PEER REVIEW MEMORANDUM

* Peer Review continued from July 1, 2004

CASE NAME: Unimatic Manufacturing Corp.CASE NO.: E20010335JOB NO.: A1988200LOCATION: 25 Sherwood Lane, Fairfield, Essex County

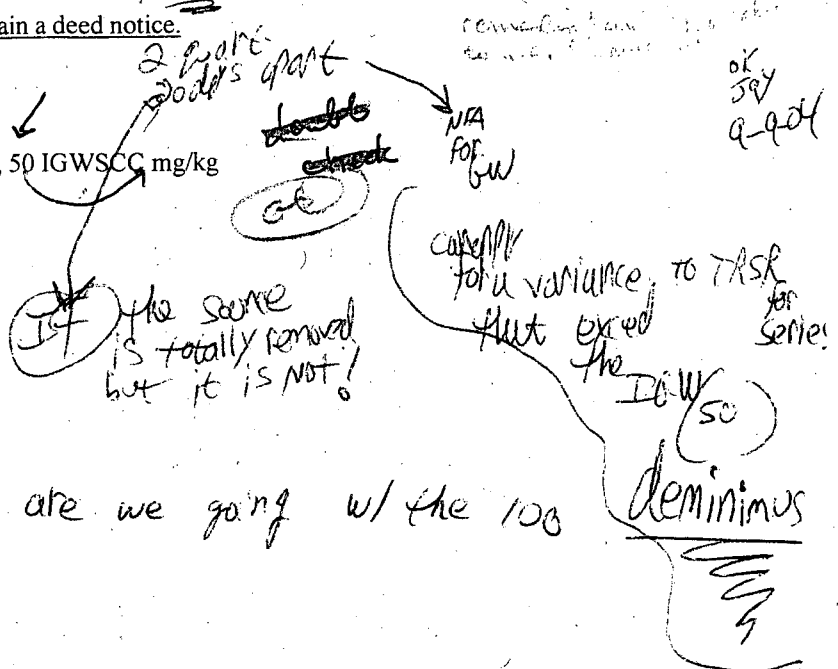
1. Need approval for RP's proposed wells MW-4 (replacement for MW-2) and MW-5.
2. Need approval for the additional well placement, that I selected, in areas of soil that exceed 100-ppm.

3. Ok for placement of an additional well, that I selected, for triangulation that is not in a PCB investigated area.
4. Is it acceptable to not require a well through the floor, inside the building, to monitor VOCs and PCBs?

1. Ok to install wells MW-4 and MW-5 as proposed by the RP.
2. The additional property well boundary (as outlined item #2, at July 1 peer review) will be placed at soil sample locations PE-14 and SPE-21. This is necessary because PE-14 has 2,061-ppm of PCB at the 15 to 15.5 foot interval and SPE-21 has 3.37-ppm at the 15.5 to 16 foot interval. This will need to be investigated due to such a drastic decrease in PCBs in only one-half foot deeper.

3. An additional well that is needed for triangulation can be installed to the southwest or northwest of the building. The RP can select the proposed well location.
